# TOWER 2, LEVEL 23 DARLING PARK, 201 SUSSEX ST SYDNEY NSW 2000

#### SUBMISSION RE: INGLESIDE PRECINCT STRUCTURE PLAN

Urbis has been instructed to review and prepare this submission in response to the exhibited Ingleside Precinct Structure Plan on behalf of Galstaun College, located on land known as Lot 1 in DP 808703, being 5 Chiltern Road, Ingleside.

## CURRENT LAND USE ARRANGEMENT AND DRAFT STRUCTURE PLAN OVERLAY

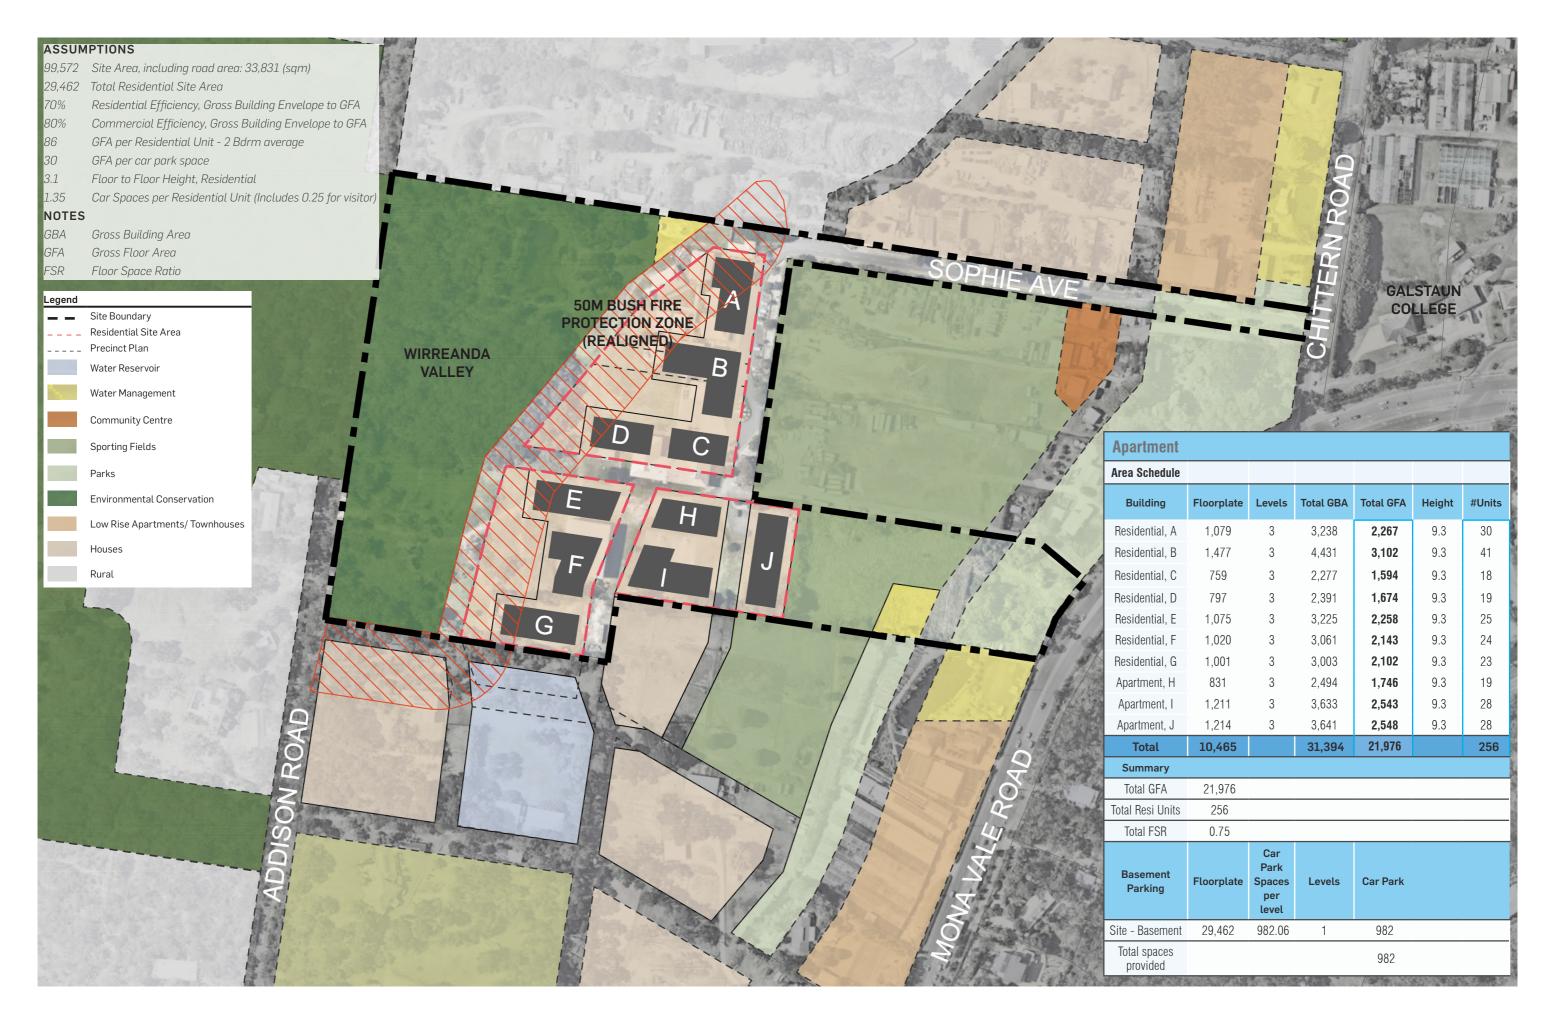
The attached plan prepared by Urbis provides an overlay of the proposed Structure Plan on the subject site. There are 2 significant issues that are dictating the potential quantum of developable land as follows:

- The most obvious constraint on the site is the effect of the proposed APZ, marked in red hatch. Aside from an apparent anomaly in the mapping of the APZ in the central portion of the site (resulting in a triangular area of apparent bushfire unconstrained land), the APZ as depicted:

- represents a significant land take on what is otherwise identified as land suitable and shaded for residential land use.
  - Extends across land that is already developed for the existing school, including school buildings.

- These issues warrant a need for further examination of the appropriateness or otherwise of the APZ in this location.
- The other significant issue is the site's affectation by the proposed sporting fields which also extend across adjoining lands. It is noted that the proposed sporting fields partly extend over existing school grounds and facilities, including basketball courts and a car parking area.
